Subject: Indian Point Unit 3
Docket No. 50-286
Additional Information Regarding IE Bulletin No. 80-04
PWR Main Steam Line Break Analysis with Continued Feedwater
Addition

ADDITIONAL INFORMATION RELATED TO A MAIN STEAM LINE BREAK
WITH CONTINUED FEEDWATER ADDITION
(IE BULLETIN No. 80-04).

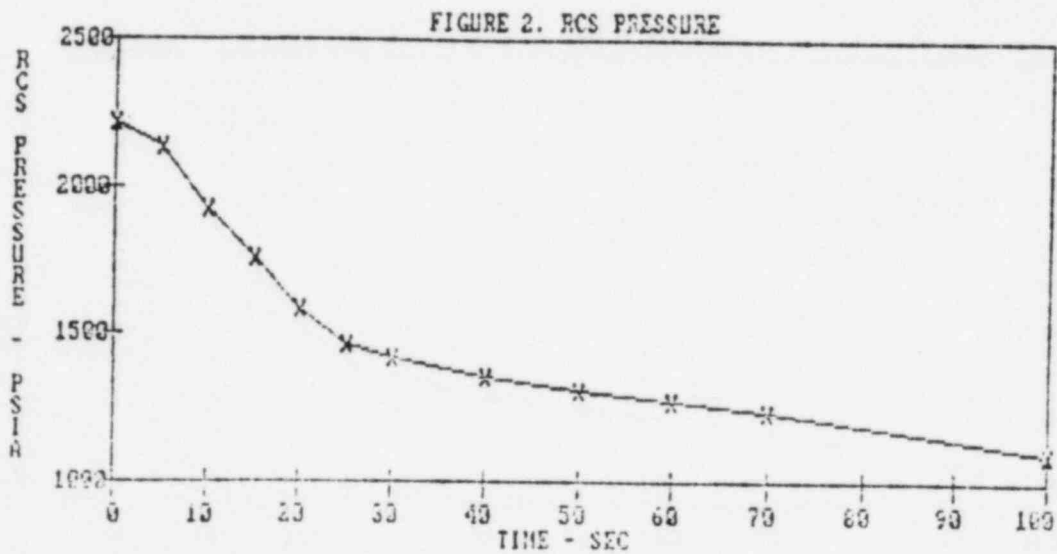
- B. Provide the following information concerning your analysis of reactivity response which results from a MSLB with continued feedwater addition.
 - 1. An analysis of the core reactivity response to a MSLB considering the effects determined in Part A, Request 1.

The worst feedwater addition case was calculated to be the full break upstream of the main steam line flow restrictor at initial operating conditions at 70% rated power. For this worse case, the core remained subcritical throughout the transient because the negative Doppler reactivity feedback and the scram shutdown reactivity margin compensate for the positive reactivity feedback due to the moderator density increase caused by the overcooling transient.

Figure 1 shows the calculated core reactivity response. Figures 2 through 8 give the transient RCS pressure, average core temperature, cold leg temperature of the loop with the broken steam line, the broken steam generator pressure, feedwater flow, break mass flow rate and liquid level. The resultant feedwater flow rate dependence on the steam generator pressure is shown in Figures 5 and 6.

FIG. 9 CONTAINMENT PRESSURE RESPONSE

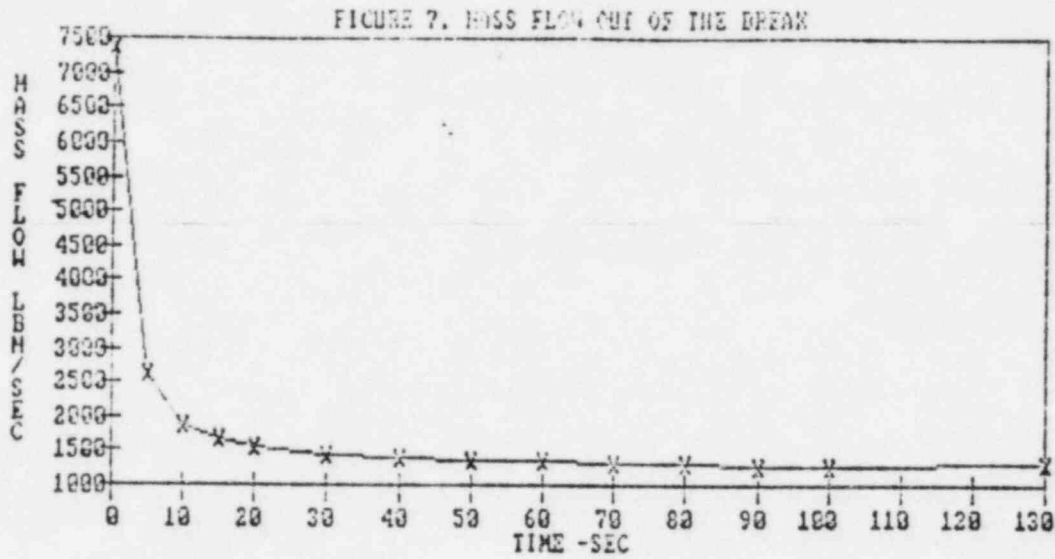
- A. Provide the following information concerning your analysis of containment pressure response to a MSLB with continued feedwater addition:
 - 1. An evaluation of the potential for a single active failure in the MFW system which could cause the greatest feedwater flow to the affected steam generator during a MSLB accident and a determination of MFW flow rate to the affected generator if a single active failure were to occur.

- 2. An evaluation of the potential for exceeding containment design pressure using the feedwater runout flow rate identified in Request 1 above. Provide justification for the assumptions made in the evaluations.

Of the three worst blowdown cases analyzed, the maximum containment pressure was calculated to be 44.6 psia. This value is well below the containment design pressure of 62.0 psia. Accordingly, the integrity of the containment is not violated during this postulated accident. It was found that the peak pressure occurred within a hundred seconds of the beginning of the transient. Manual operator actions was not relied upon in the analysis. Figure 9 gives the containment pressure as a function of time for the worst blowdown conditions as described above, and minimum containment safeguards (i.e., one containment spray train and three fan coolers).
